**TOWN OF LOS GATOS
PLANNING COMMISSION
REPORT**

DATE: July 19, 2024
TO: Planning Commission
FROM: Joel Paulson, Community Development Director
SUBJECT: Requesting Approval for Modification of Planned Development Ordinance 1412, Subdivision of One Lot into Two Lots, Construction of a Single-Family Residence, and Site Work Requiring a Grading Permit on Property Zoned O:PD. **Located at 120 Oak Meadow Drive.** APN 529-10-131. Subdivision Application M-20-011, Planned Development Application PD-20-002, Architecture and Site Application S-22-021. Categorically Exempt Pursuant to CEQA Guidelines Sections 15315: Minor Land Divisions; 15303: New Construction; and 15304: Minor Alterations to Land. Property Owner: Marty and Penny McFarland. Applicants: Terence J. Szewczyk (M-20-011 and PD-20-002) and Jay Plett, Architect (S-22-021). Project Planner: Sean Mullin.

The Town's Consulting Architect reviewed the proposed residence on May 10, 2022 (Exhibit 10). In the report, the Consulting Architect noted that the applicant has done a good job fitting the house into the difficult site by working around the existing large trees. The Consulting Architect identified two issues and concerns and pro

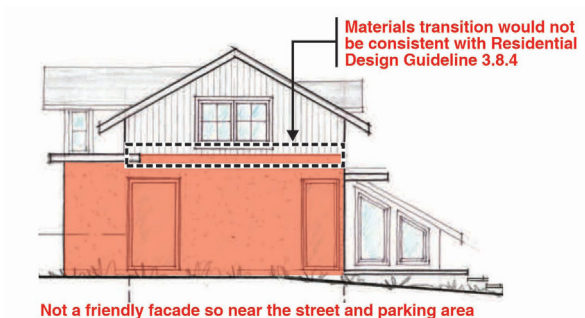
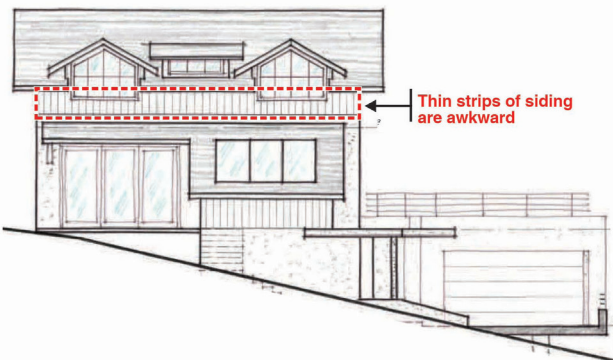
Large amount of stucco would be out of character with this neighborhood and not consistent with Residential Design Guideline 3.8.2

2. The small areas of wood siding on the front and rear elevations is awkward, and the materials change in the same plane which would not be consistent with Residential Design Guideline 3.8.4.

RECOMMENDATIONS

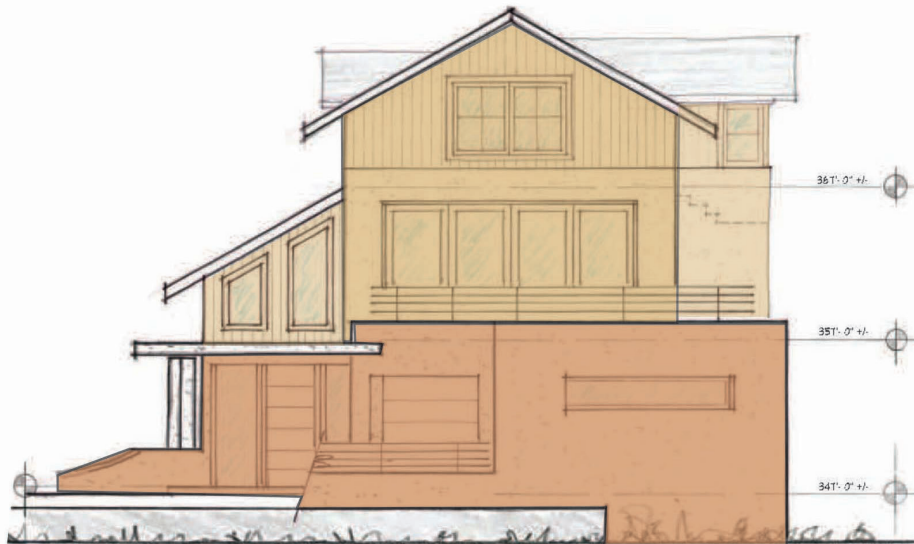
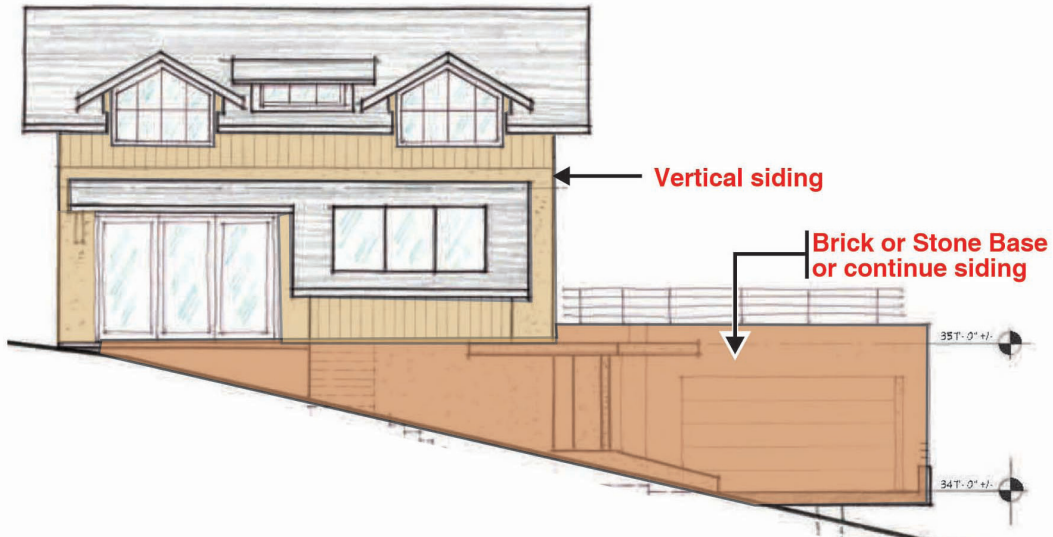
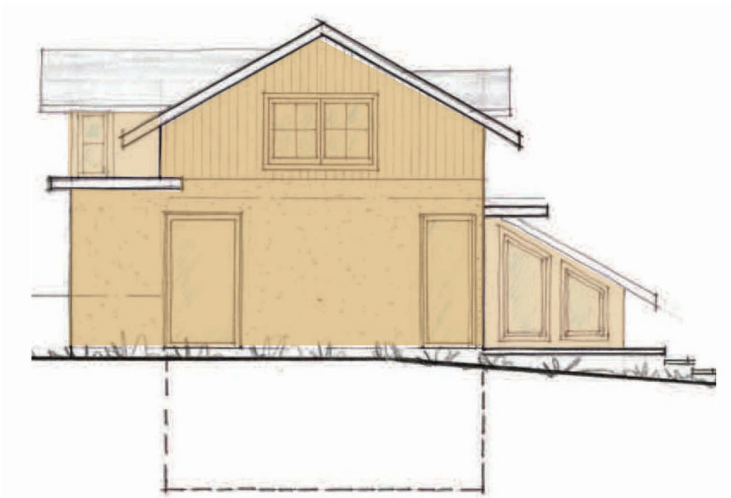
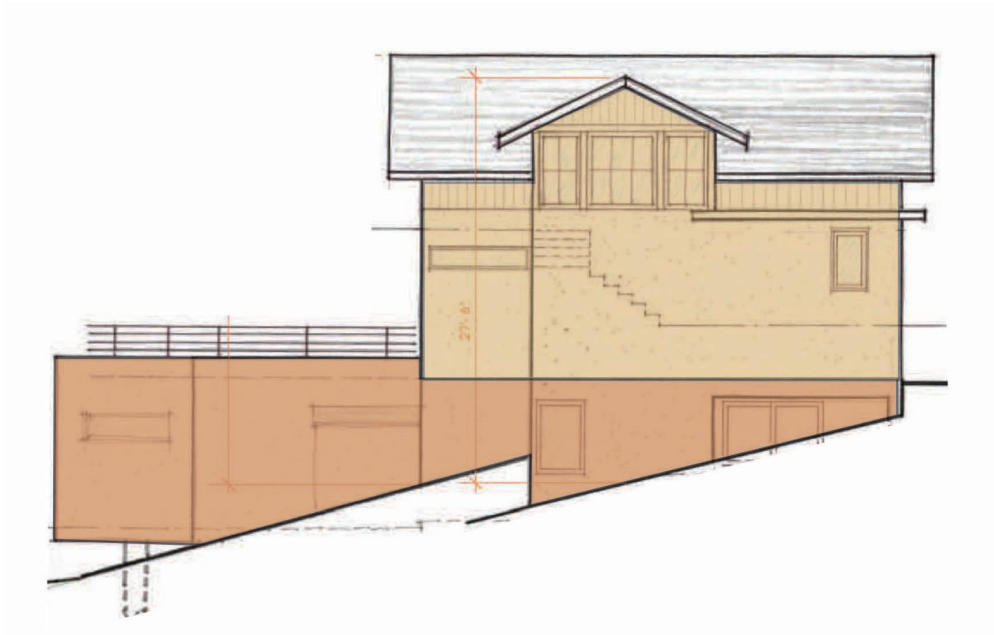
1. Reduce the large amount of stucco on the house by extending the vertical siding consistently down to the first floor line. **See prior response.**
2. Use brick or stone for the building base below the first floor line or continue the use of vertical siding in this area. The adjacent existing home on this larger parcel has a prominent brick base - see photo below. If brick or stone is used, provide a projecting brick or stone ledge at the transition with any vertical siding. If vertical siding is used, add a horizontal belly band to break up taller wall planes. **Horizontal belly band is not appropriate for this home. If we were transitioning from one wood above and another type of wood below, then a belly band might be appropriate, but ours is not the case. In this case, a belly band is not warranted or desirable.**

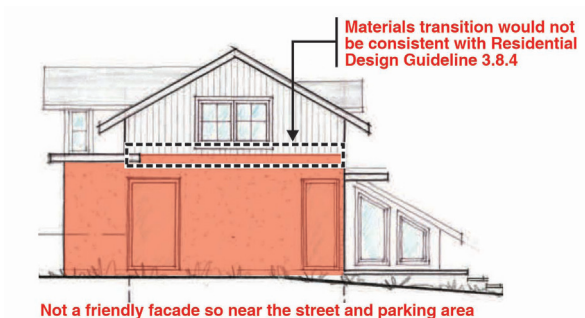
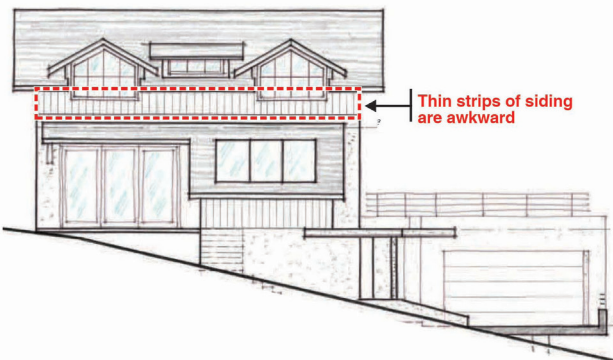
Large amount of stucco would be out of character with this neighborhood and not consistent with Residential Design Guideline 3.8.2

2. The small areas of wood siding on the front and rear elevations is awkward, and the materials change in the same plane which would not be consistent with Residential Design Guideline 3.8.4.

RECOMMENDATIONS

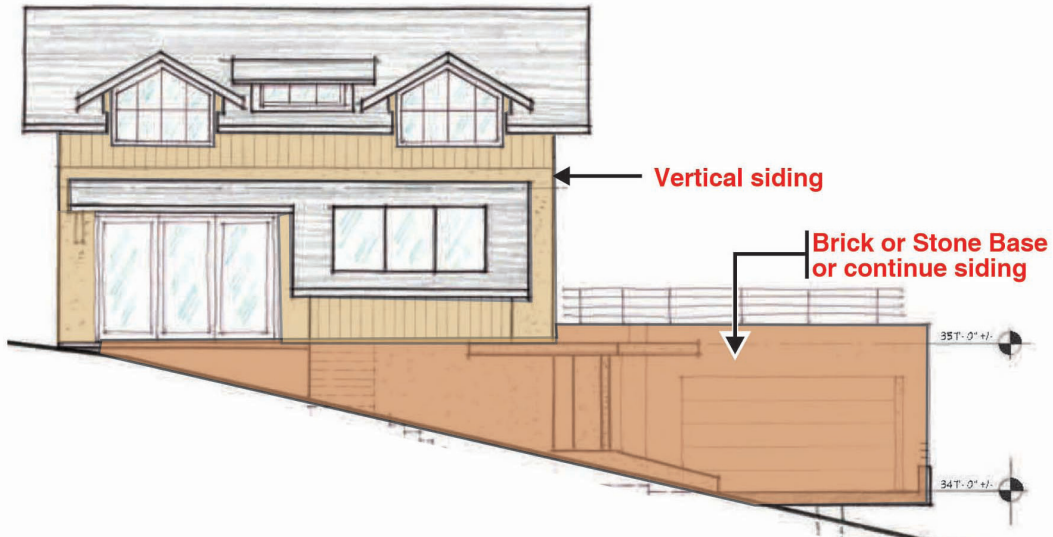
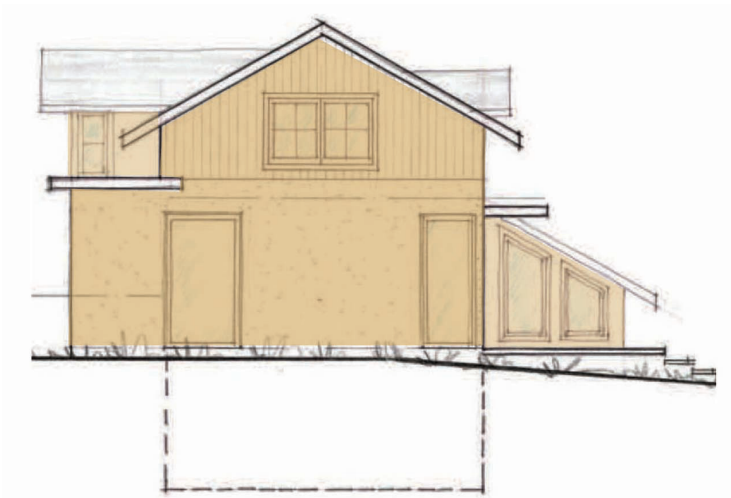
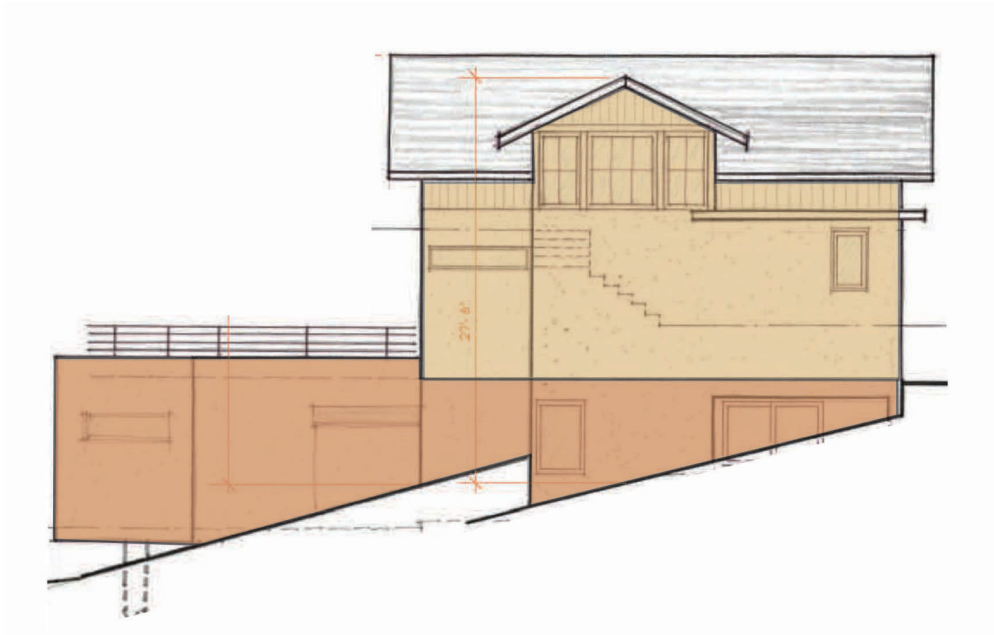
1. Reduce the large amount of stucco on the house by extending the vertical siding consistently down to the first floor line. **See prior response.**
2. Use brick or stone for the building base below the first floor line or continue the use of vertical siding in this area. The adjacent existing home on this larger parcel has a prominent brick base - see photo below. If brick or stone is used, provide a projecting brick or stone ledge at the transition with any vertical siding. If vertical siding is used, add a horizontal belly band to break up taller wall planes. **Horizontal belly band is not appropriate for this home. If we were transitioning from one wood above and another type of wood below, then a belly band might be appropriate, but ours is not the case. In this case, a belly band is not warranted or desirable.**
